DEPARTMENT OF TRANSPORTATION
STATE OF GEORGIA

GDOT District 7 - Metro Atlanta
Fulton County
I-75 @ CR 624/Mt. Paran Rd &
SR 3/US 41 @ CR 624/Mt. Paran Rd

SUBJECT **APPROVED REVISED CONCEPT REPORT**

DEPARTMENT OF TRANSPORTATION
STATE OF GEORGIA
REVISED PROJECT CONCEPT REPORT

TS-4
MT. PARAN
WIDENING/MILL & INLAY
STA. 51+50 TO STA. 56+00

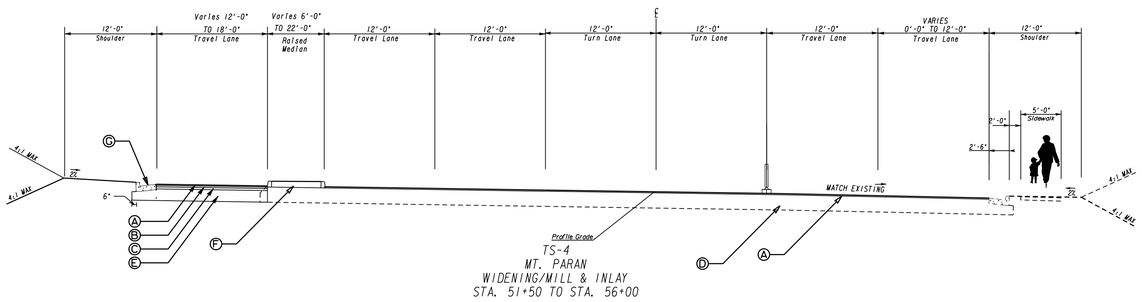
Approved Features:	**Proposed Features:**
The Approved Concept Report mentions a roadway typical Section for Mt. Paran Rd to include the following: six 12-foot travel lanes (2 lanes NB and dual left turn lanes, a shared through and right turn lane, and a dedicated turn lane from the I-75 SB ramp to NB SR 3/Northside Pkwy on the SB side) with 2½ -foot curb and gutter on both the east and west side of the roadway. The dedicated turn lane will be separated from the SB Mt. Paran Rd mainline traffic by a 3-ft to 16-ft raised median to eliminate the existing weaving section.	Mt. Paran Rd will now include the following: seven 12-foot travel lanes (2 lanes NB and dual left turn lanes, a through lane, a right turn lane, and a dedicated turn lane from the I-75 SB ramp to NB SR 3/Northside Pkwy on the SB side) with 2½ -foot curb and gutter on both sides of the roadway. The dedicated turn lane will be separated from the SB Mt. Paran Rd mainline traffic by a 6-ft to 22-ft raised median.

Potential environmental impacts of proposed revision: Mt. Paran Rd will be widened by 12 feet to the west between the I-75 SB off-ramp and Northside Pkwy to accommodate the additional width of pavement needed for the new right turn lane. This minor widening will require some additional earthwork and a retaining wall, but it will not require any ROW or Easement as the Department owns the ROW between I-75 and Northside Pkwy in the area of this project. Also, this widening is not anticipated to have any environmental impacts as there were no identified resources in the initial screening, and it should not impact the project schedule.

Reason(s) for change: The above typical section change is being made per the results of the most recent traffic models and several project shareholder meetings with the local neighborhood groups. They both showed that separating the shared through-right lane on the southbound Mt Paran Rd approach of intersection at US 41/SR 3/Northside Pkwy would be beneficial for improving traffic flows and reduce delays at this intersection/interchange along with providing the already proposed separated turn lane from the I-75 SB exit ramp shows.
